Federal Aviation Administration

Memorandum

Subject: ACTION: Review and Concurrence, Equivalent Level of Safety (ELOS) to 14 Code of Federal Regulations (CFR) § 23.783(f)(1): Finding Number: ACE-05-26

Figure A depicts the 14 CFR § 23.783(f)(1) design requirement. Figure B depicts the ELOS ACE-98-3 opening with the encroachment of the cockpit bulkhead.

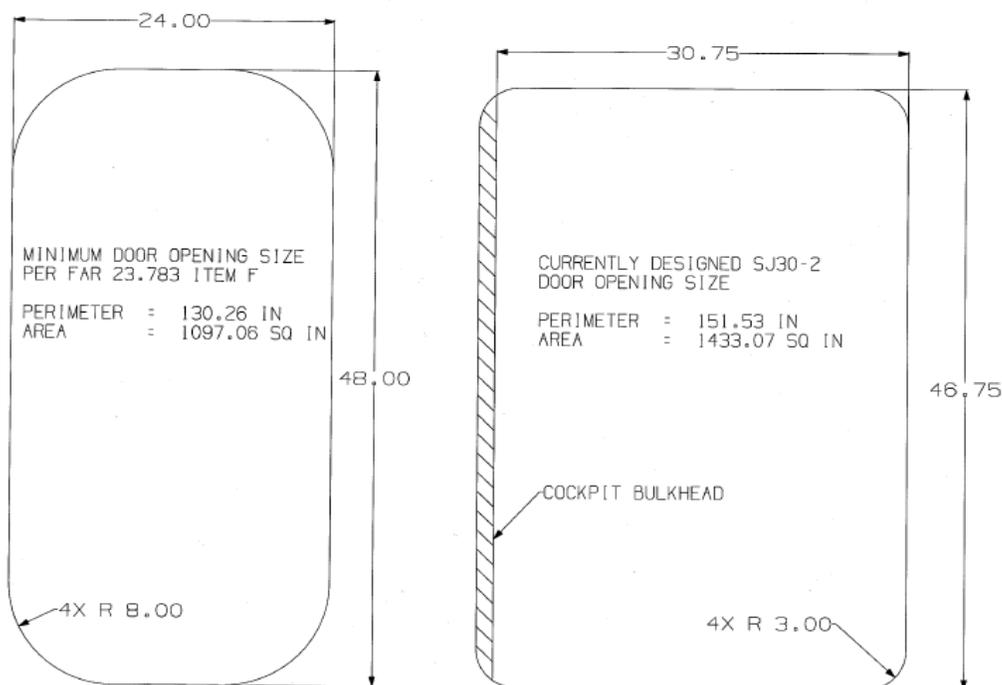
The completed SJ30-2 aircraft interior includes a bulkhead to separate the cockpit from the remainder of the cabin. In its installed position, the bulkhead encroaches approximately 1.25” into the forward edge of the opening of the main cabin doorway. This encroachment reduces the effective width of the main cabin door as previously approved in ELOS Finding No. ACE-98-3.

With the installation of the cockpit bulkhead, 1.25 inches in main cabin door opening width is lost by the encroachment of the bulkhead into the forward edge of the main cabin door opening. The net effect is a door opening width of 30.75 inches, and a total area of 1,433 square inches. This effective door opening now has a “margin” of 30.6% over the regulatory requirement.

The 3-inch radius at the corners remains structurally unchanged. The cockpit bulkhead encroaches only in the inside of the aircraft on the forward edge of the main cabin door opening, that is, the projected effective door area available for evacuation is reduced.

The FAA concurs with the applicant's assessment that the emergency evacuation would remain successful as intended by the regulation. The FAA considers this reduction in effective projected opening area to be a small and inconsequential impact on intended evacuation requirements. The Door opening area with a margin of 30.6% over the regulatory requirement continues to be sufficient to adequately offset the lower height.
